Model	CD510R, Rex1040	Volt/Hz	Date of Modification	Serial Number
Modified Article	Print Pressure Cam	C201 - 22		After Mar. '91
Reason for Modification	To ensure the printing quality on the leading part			
		C201 - 24		After Mar. '91

DETAILS OF MODIFICATION

Model	SS810/830, Ges5110	Volt/Hz	Date of Modification	Serial Number
Modified Article	Print Pressure Cam			
Reason for Modification	To ensure the printing quality on the leading part

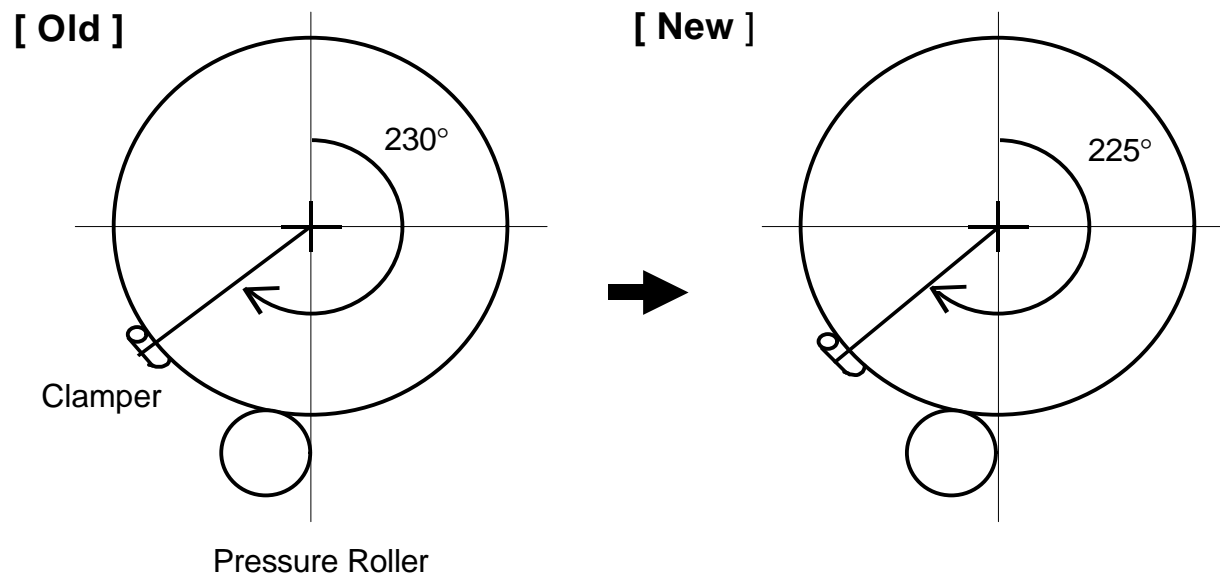
To ensure the printing quality on the leading part of the paper, the shape of the print pressure cam has been changed. If there is solid fill image on the leading part of the original and the printing speed is high (4 or 5 step), a low density horizontal band may appear about 30 millimeters from the leading edge of the print. This is caused by pressure roller bound when the pressure roller contacts the drum surface. The new print pressure cam applies the print pressure to the pressure roller 5 degrees faster in the drum rotation angle. (The pressure roller contacts the drum about 7 millimeters before the leading edge of the paper.)

NOTE: When the new print pressure cam is installed, the exit pawl timing is also changed. (The exit pawl approaches the drum 5 degrees faster in the drum rotation angle.) Therefore, it is necessary to make sure that the exit pawl does not contact the master clamper. (Readjust the exit pawl timing if necessary.)

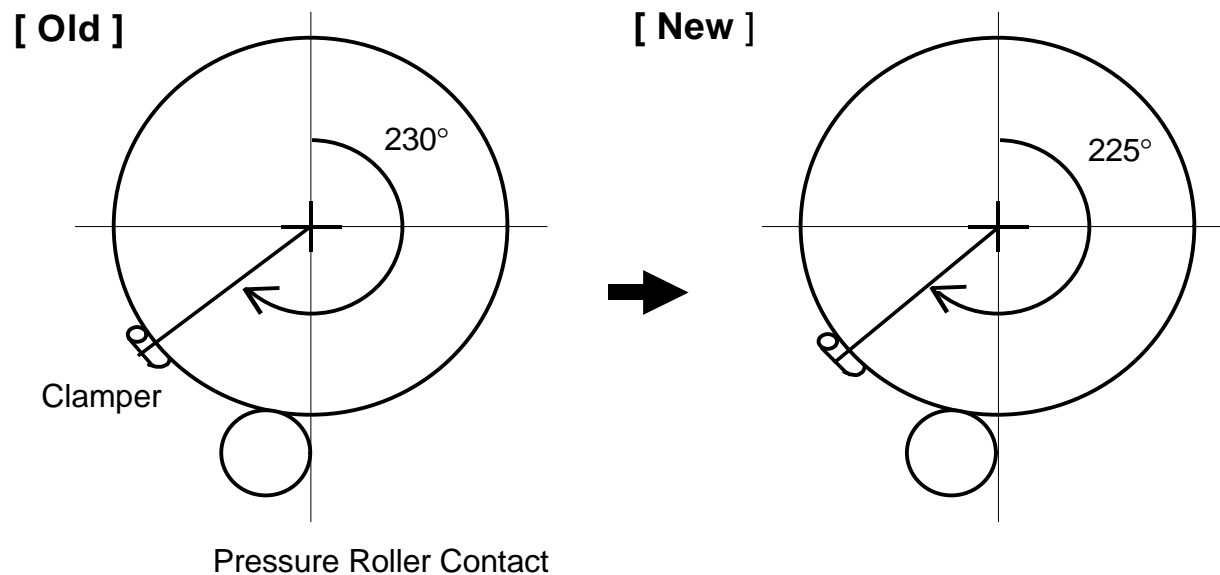
To ensure the printing quality on the leading part of the paper, the shape of the print pressure cam has been changed. If there is solid fill image on the leading part of the original and the printing speed is high (4 or 5 step), a low density horizontal band may appear about 30 millimeters from the leading edge of the print. This is caused by pressure roller bound when the pressure roller contacts the drum surface. The new print pressure cam applies the print pressure to the pressure roller 5 degrees faster in the drum rotation angle. (The pressure roller contacts the drum about 7 millimeters before the leading edge of the paper.)

NOTE: When the new print pressure cam is installed, the exit pawl timing is also changed. (The exit pawl approaches the drum 5 degrees faster in the drum rotation angle.) Therefore, it is necessary to make sure that the exit pawl does not contact the master clamper. (Readjust the exit pawl timing if necessary.)

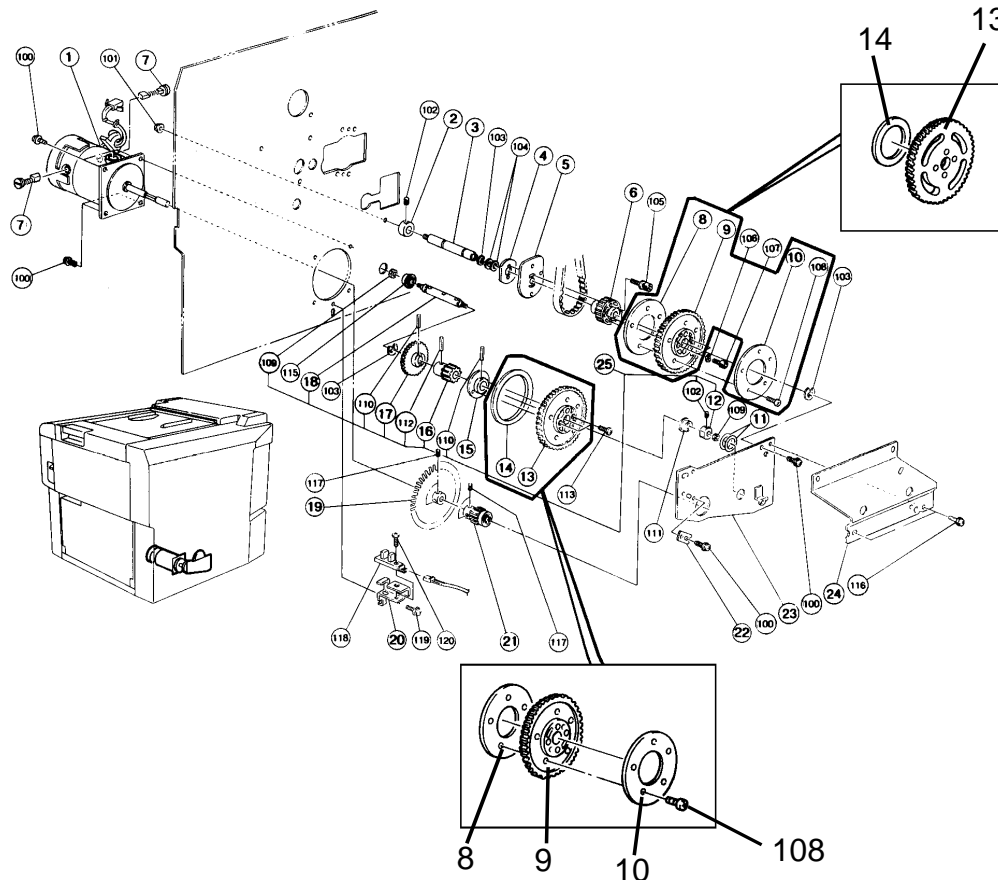
Please correct the illustration on page 9 as shown below.
